## SoundOff Water Intrusion

### Parts Update #17-08

### SoundOff Lighting – 7” Round Product

Illustration #1

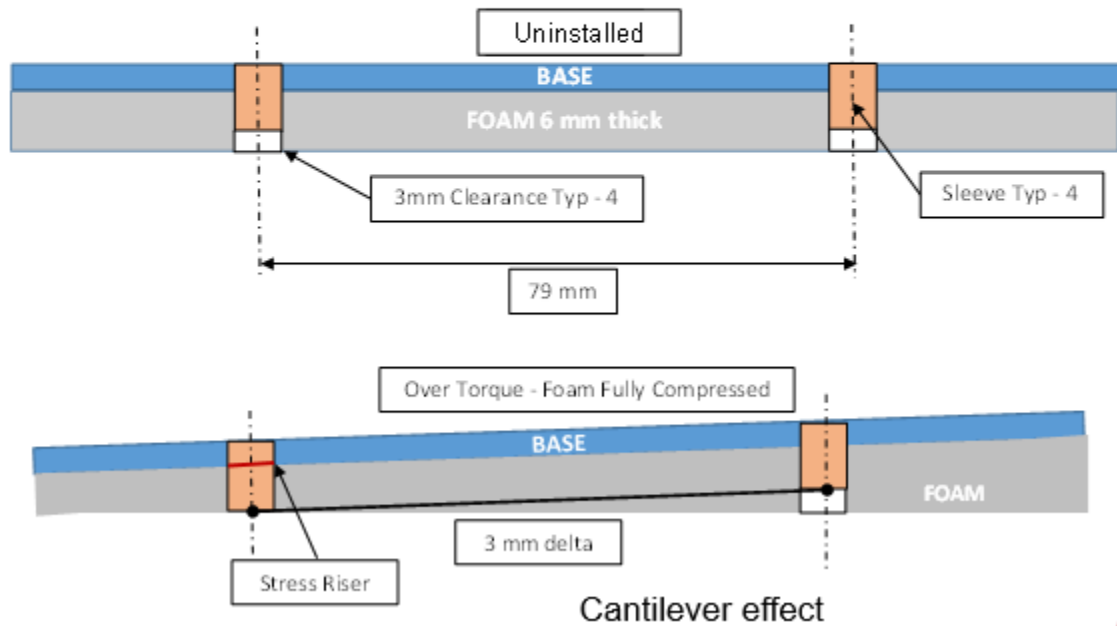
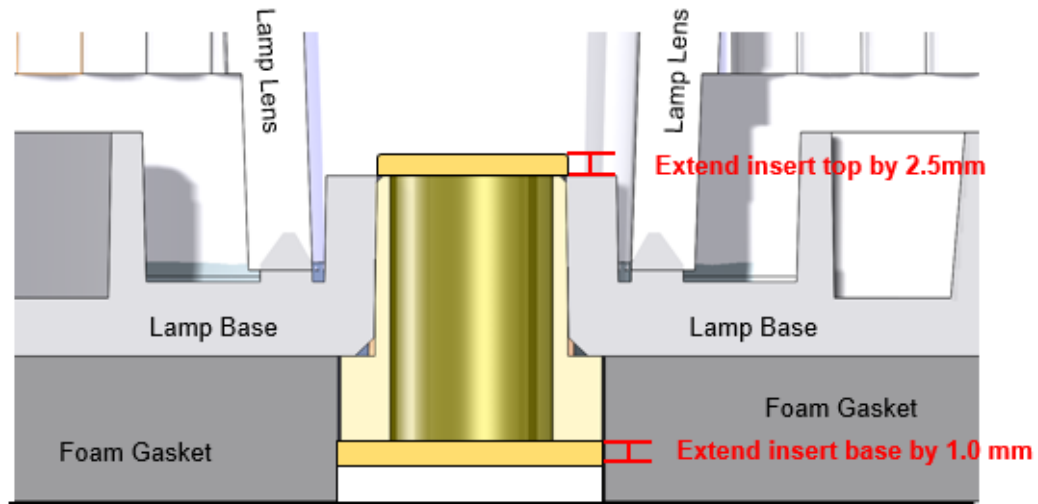
## Cantilever Effect

Over torquing of screws during installation can cause lamps to crack at installation or propagate latent failures

Illustration #4

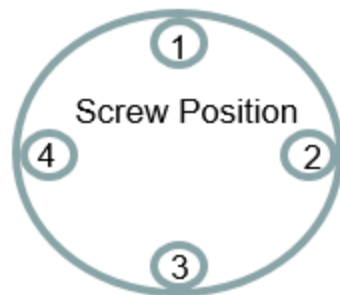
## DOE Procedure

16. Water test all lights in dunk tank, at 10-12inHg for at least 5 seconds. Note any leaks. See Figure 4.
17. If part passes water test, wipe dry and save part, if applicable repeat experiment steps at prescribed higher torque setting.
